HOWARD CHEVROLET

PRELIMINARY PLOT PLAN

HOWARDS CHEVROLET

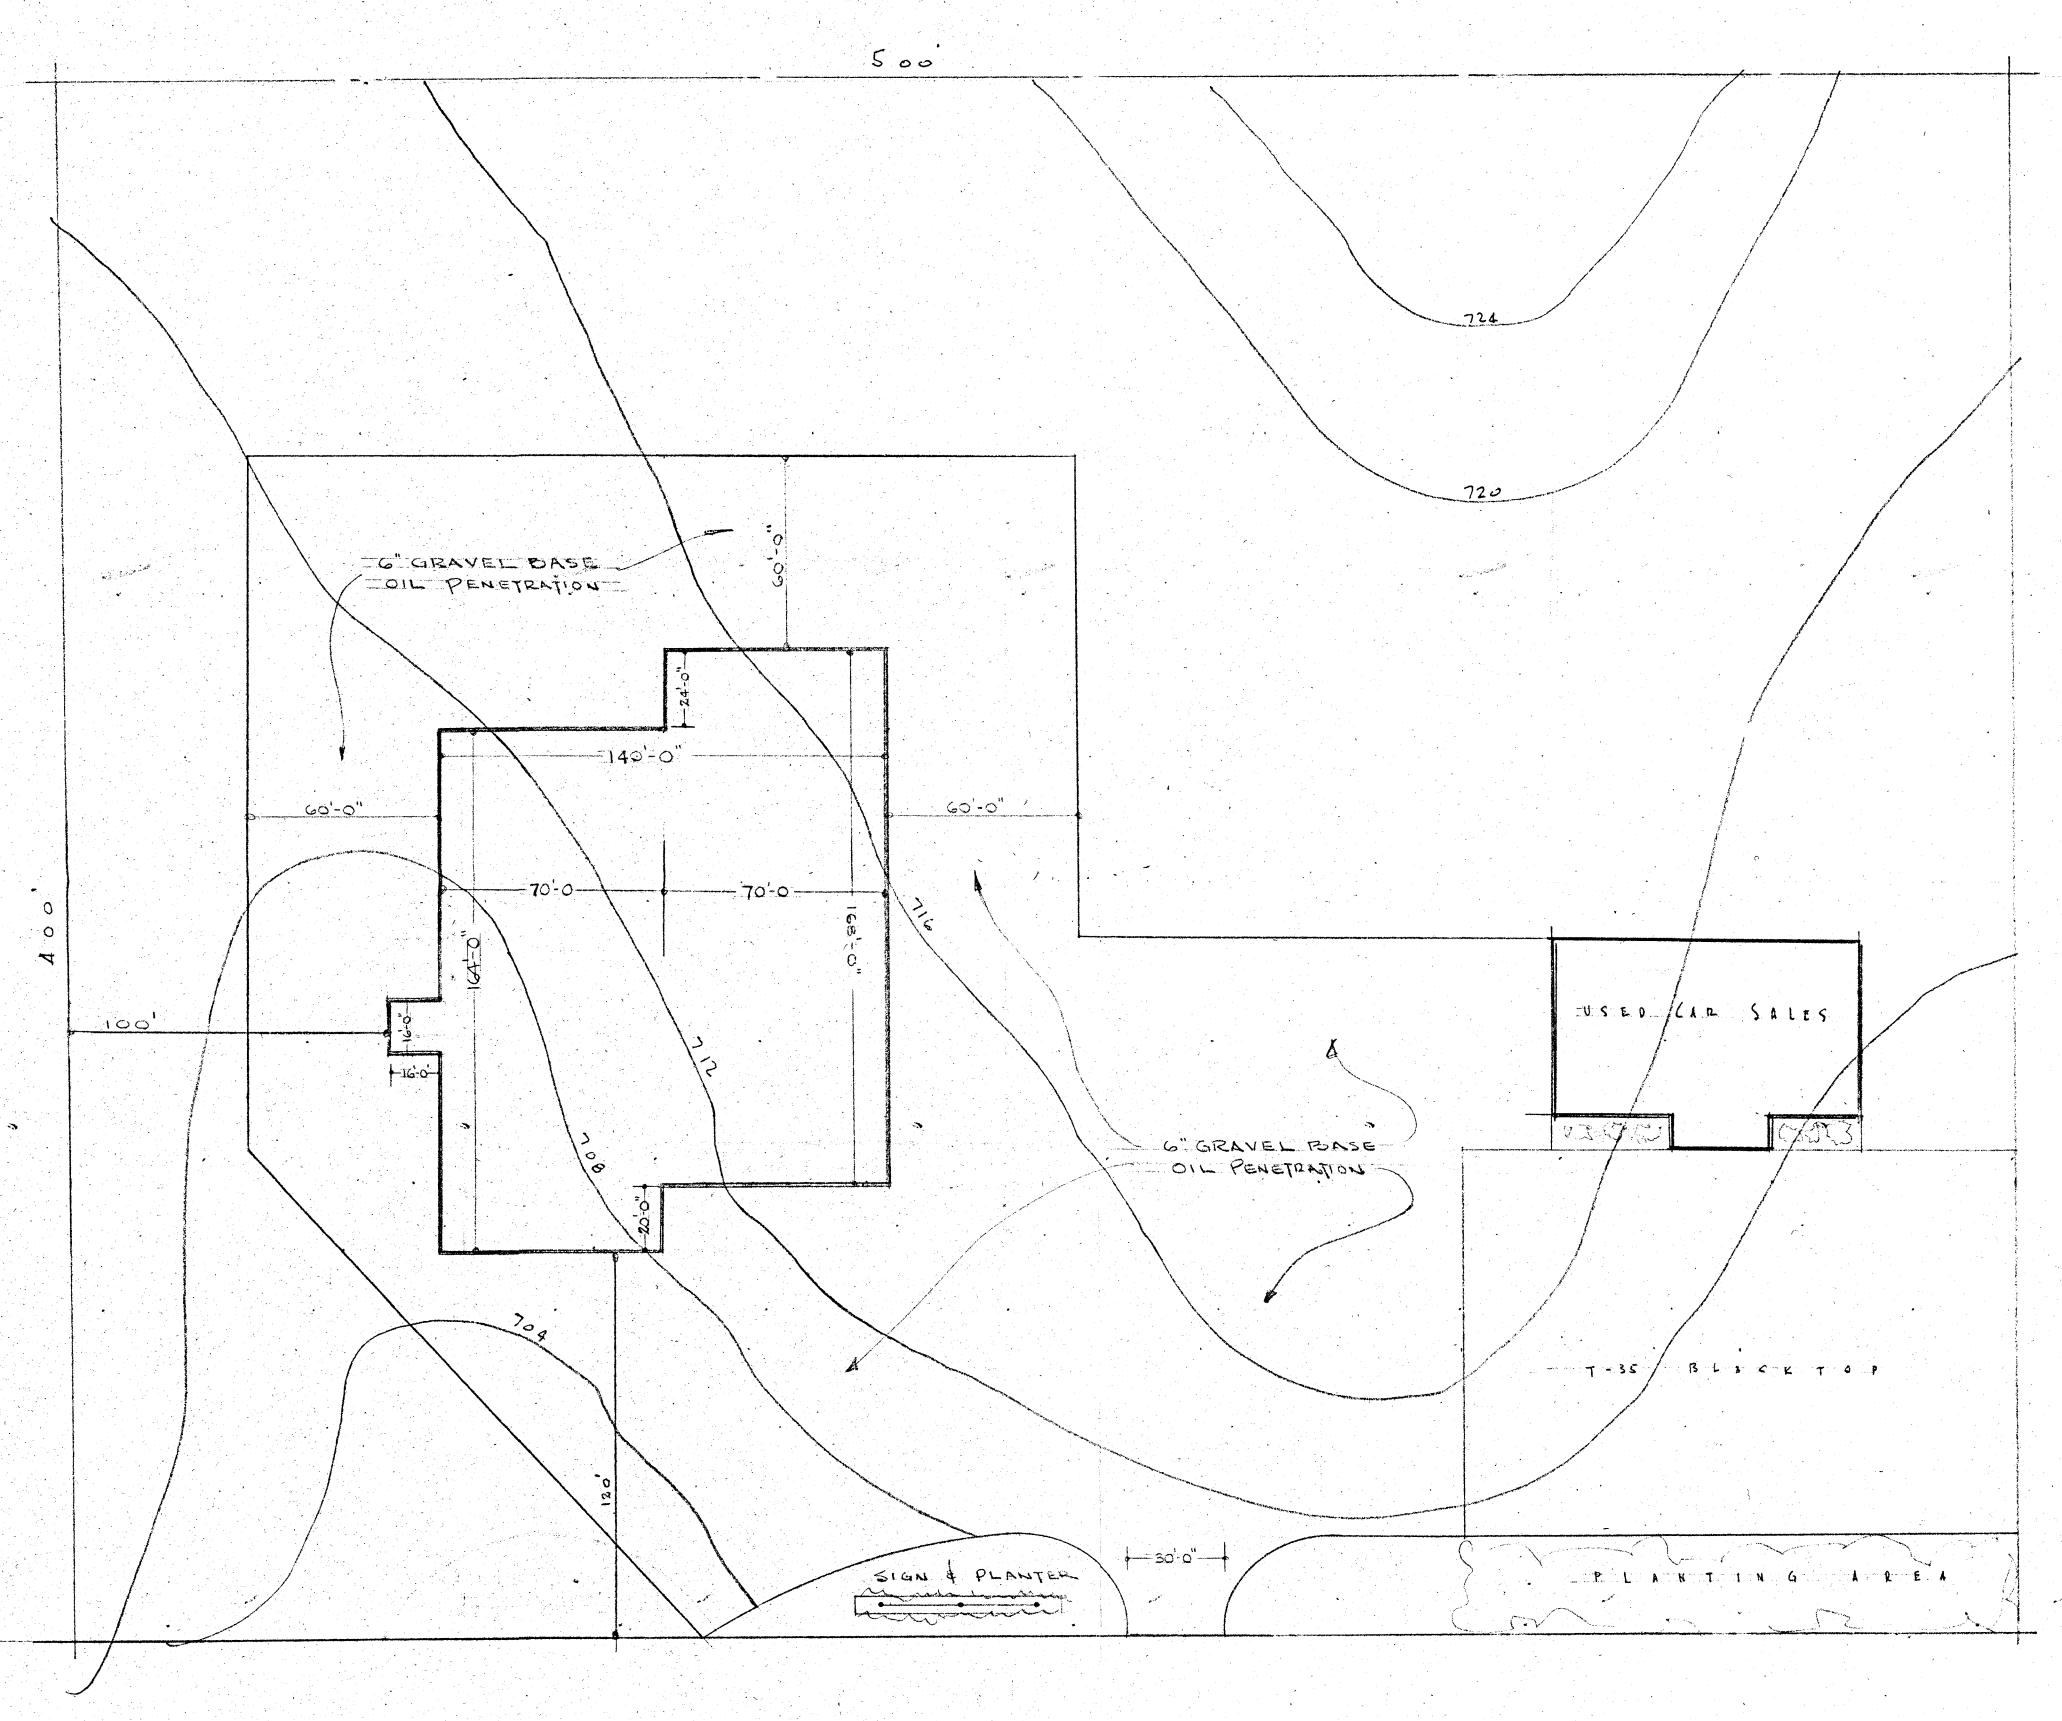
Enclosed is the latest Plot Plan of your site. I believe the locations to be correct.

I want you to note the difference in grades between Mr. Stapleton and Mr. Strain's topo. I called Mr. Stapleton this mouning, Monday, August 26, and found out he assumed an elevation of 500 from, I believe, a fire hydrant. He mentioned that Mr. Strain took his topo from a government topo print. These prints generally vary both horizontilly and vertically.

I would like to suggest we have Mr. Stapleton take this Plot Plan and tie down these elevations. At the same time, I would like to have center line grades every 100° in front of the property. I will also shown the general location of the septic system leaching field and if satisfactory with you, Mr. Stapleton should make a percolation test for the Health Department.
